MIAMI BEACH

Staff Report & Recommendation

Design Review Board

SUBJECT: DRB16-0055
1134 South Biscayne Point Road (Parcel 1) – Single Family Home

Shared driveway with variance

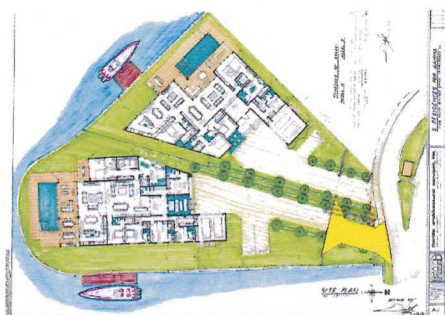
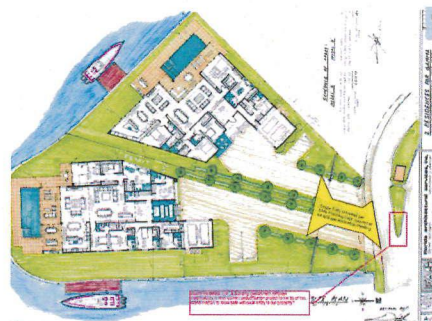
4. A variance to reduce by 4'-0" the minimum required setback of 4'-0" for a driveway in order to construct a driveway at zero setback along the side property line.

In an effort to be least disruptive to the area related to vehicular access to a lot that has site challenges, the applicant is proposing a shared driveway between this property and the companion application (DRB15-0056: Parcel 2). In order to do so, the driveway must straddle both parcels shared interior property line. This is the most practical and safest solution in order to have access to and from the new residences created as a result of the lot split. The location of the property entrance to Biscayne Point with a very narrow front, as well as the existing locations of the guardhouse and the entrance bridge, are special conditions that warrant the variance requested. The proposed driveway must **NOT** create a conflict with the center landscaped median which serves as part of the entry feature to the community currently being renovated by the CIP Department. Again, due to the narrow width of the front property line (31') and irregular shape of the lot, the variance request complies with the practical difficulties criteria. The graphics below depicts the impact of having two separate driveways for the properties and the single shared driveway.

Lot 33 of Block 7
Subject Property is the western half

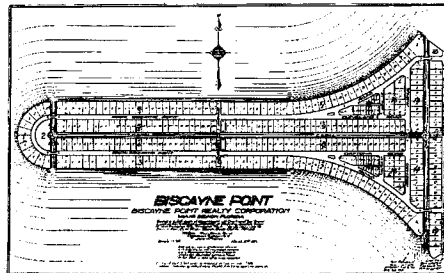
The applicant is requesting several variances for parcel 1, as a result of the lot split of the property. Similar variances are also requested on the adjacent parcel 2. The existing property with an area of approximately 33,538 SF, is within the plat of Biscayne Point Subdivision which was originally platted in 1925. The original plat contains two similar irregular shaped edge parcels. The northern parcel of Lot 33 of Block 10 is the mirror image to the subject property (before the lot split). As shown in the images below, in 1955 that lot (Lot 33 of Block 10) was also subdivided into three tracts and platted with access by a private street. In this regard, the subdivision of land, is compatible and in character with the area.

The adjacent lots to the west and north of the subject property are substantially smaller in area ranging from approximately 11,250 sf to 15,300 sf, and based on the minimum area required for the RS-3 district, the site, subject to a lot split could theoretically be subdivided in three 10,000 SF lots, as the mirror properties to the north. However, its location, irregular shape and access to the street, create practical difficulties that make this property unique in size, as it is almost three times larger in area than the surrounding properties and also subject to more restrictive rear setback requirements. Also, due to its larger area, a more massive and imposing single family home could be constructed which could negatively affect the neighborhood, as the majority of the homes are one-story structures. Staff finds that the proposed project is more compatible with the neighborhood and would not have an adverse impact in the urban context.
